## 12\_18 Criteria Update - Fixed Side Slopes

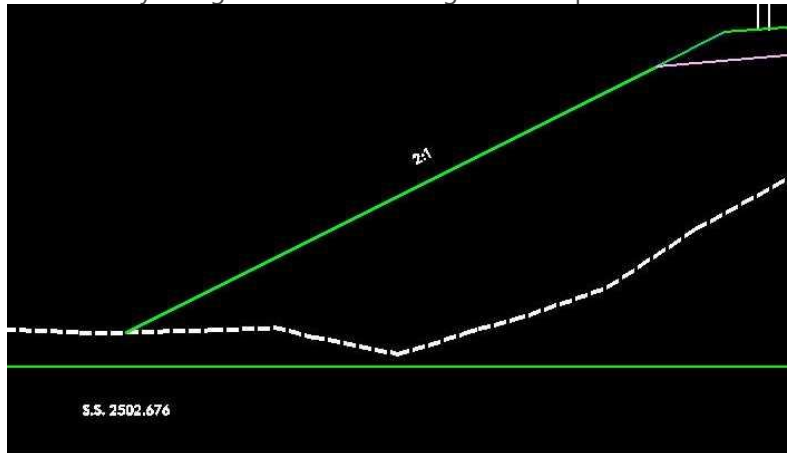
The "Fix Fill Slope" variables are not working and have not been working for a couple of months. Upon further investigation, a "slight" inaccuracy in the side slope criteria files was discovered. When Designers use the "Fix Fill Slope" variable for Freeway (FDSS) and Arterial (ADSS) Design side slopes, the slopes were drawn to an odd slope (not to the fixed value). Although not so apparent at first, the point of reference from the finished shoulder point to the slope stake point (side slope) was not localized correctly. Instead of the finished shoulder point, the guardrail face was used. See picture below.

The Freeway Design and Arterial Design Side Slope criteria files have been fixed.

The Local Design Side Slope criteria files are not affected. Even though this produces a negligible difference and only appears when guardrail is warranted for Freeway and Arterial Design side slopes, it is still worth mentioning.
